Boys Transit Station, Mandatory Referral, MR2020029

Staff Recommendation: Approval to Transmit Comments

BOYDS TRANSIT IMPROVEMENTS – 35% DESIGN

Figure 7 Cross Section – Barnesville Road – Western End of Site

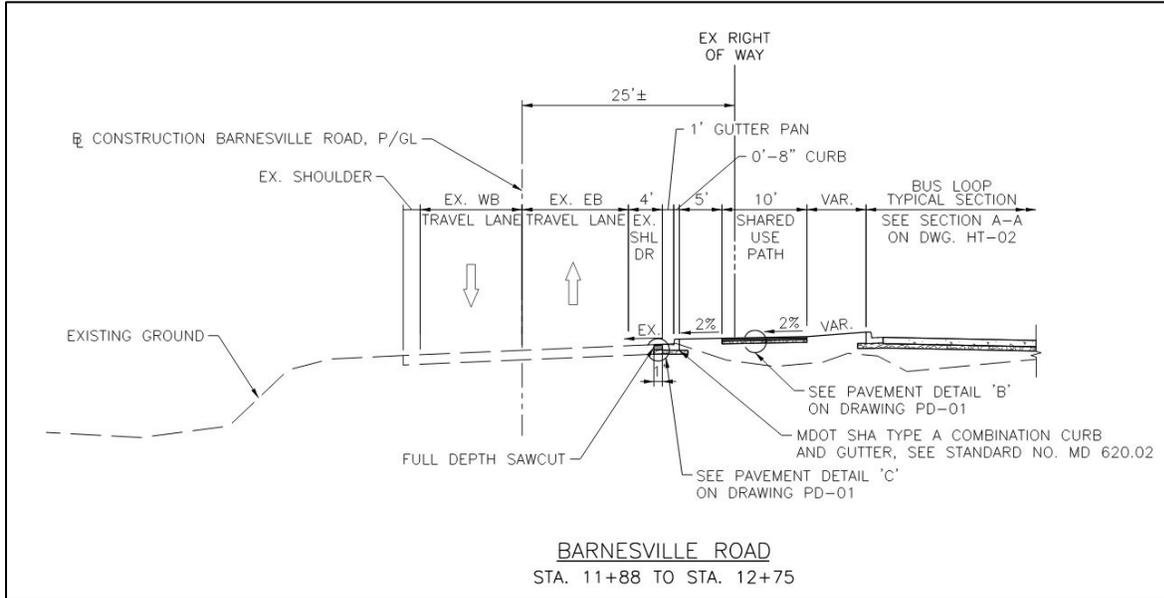
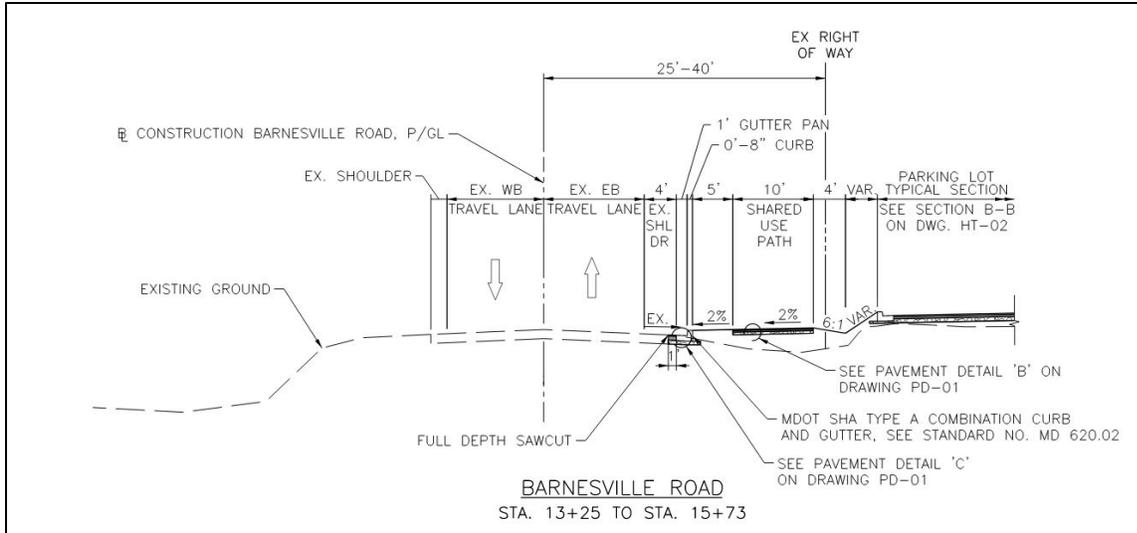
8. The proposed shoulder and curb proposed along the eastbound direction along the site frontage is inconsistent with the MARC Rail Communities Sector Plan and should be modified.

The project is inconsistent with the MARC Rail Communities Sector Plan in the provision of curbing and shoulders as identified in Recommendation 3c (Boyds) on page 46, which specifically states "Classify Barnesville Road as a country road. Shoulders [and curbing] should not be added to the roadway to maintain the rural character of the area."

Figure 9: Profile – Barnesville Road (excerpt from plans) showing transit center driveway and bus egress locations

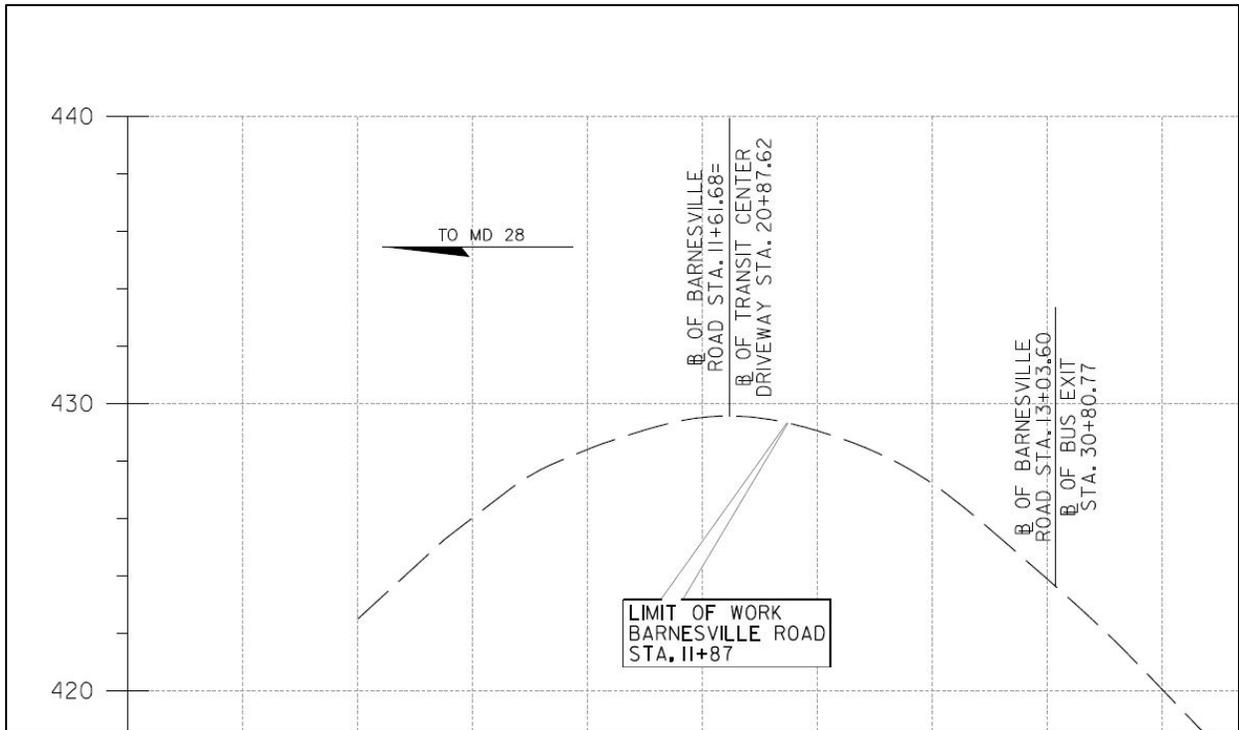
4. Design the grade, cross slope and material of the proposed sidepath to be level across both site driveways.
5. The applicant should work with the state to reduce the posted speed limit to 25 mph to match the Master Planned target speed of 25 mph. This will mitigate the sight distance deficiency at the egress drive.

6. The bus only egress is problematic and is likely to be used by cars, despite signage. This is a safety hazard because it has deficient sight distance for cars due to the existing vertical curvature. We recommend that additional measures, including a possible bus-activated gate, be considered to prevent autos from using this egress.

7. Consider alternatives to move the bus egress further west to avoid sight distance issues, which might require either shortening the bus stop primarily in front of the Poolesville Small Engine Repair Shop or by moving the bus stop further west as well (and this might impact the three parking spaces provided on the western side of the site).

The internal site circulation is awkward for this site design, primarily due to a sight distance deficiency at the eastern driveway access. Due to a sight distance deficiency for cars but not buses, MCDOT has proposed that this driveway be restricted to car traffic, allowing this driveway to be used by buses for egress only (and typically a right turn onto Barnesville Road). The existing profile of Barnesville Road is shown in Figure 9. You will note that the proposed transit center drive is located at the crest of the hill, while the eastern drive is located downhill.

Figure 10: Pavement and Circulation Plan

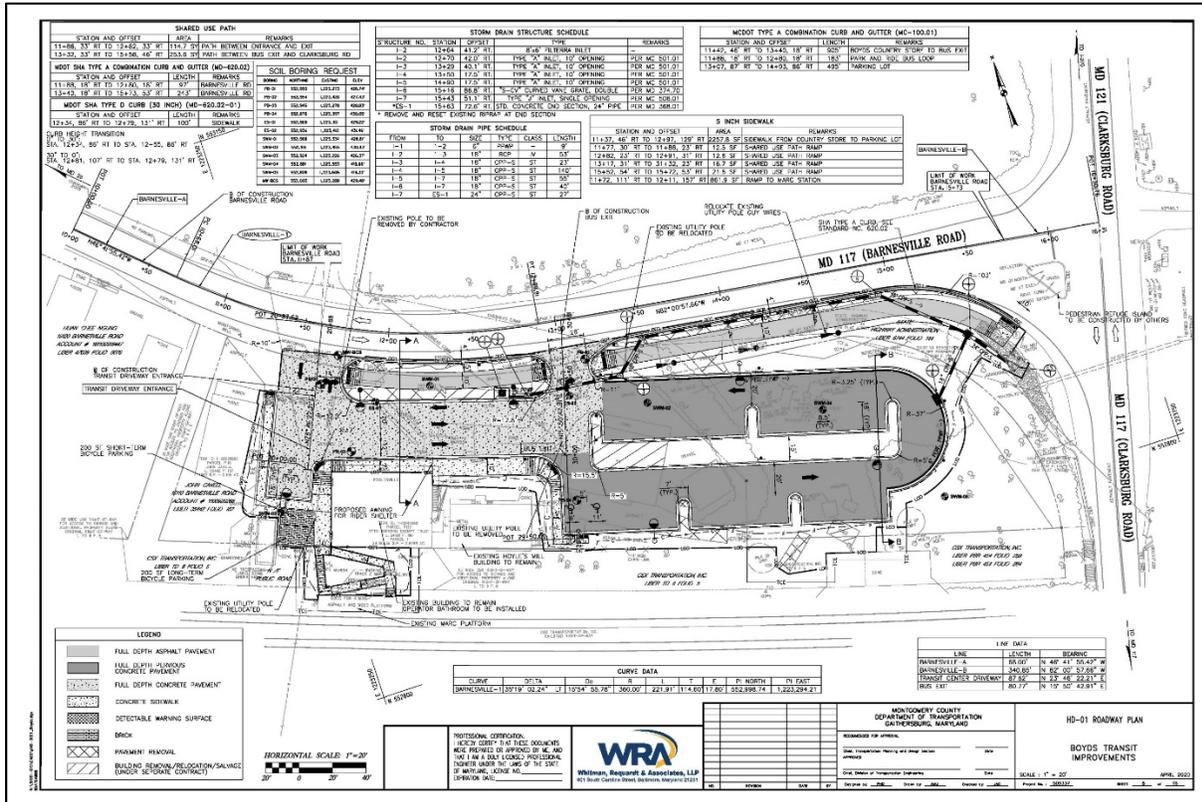
12. For the next design phase, more detail should be provided for the bicycle parking. This parking should be designed in conformance to Section 6.2.6 of the Montgomery County Zoning Code. It is important to note that each long-term bicycle parking space must be provided within a building, covered parking garage, or secure parking area located near the building or structure and the street or other bicycle right-of-way.

13. The two accessible parking spaces should be relocated to the western side of the site (near the proposed bike parking area) to be more proximate with the CSX platforms.
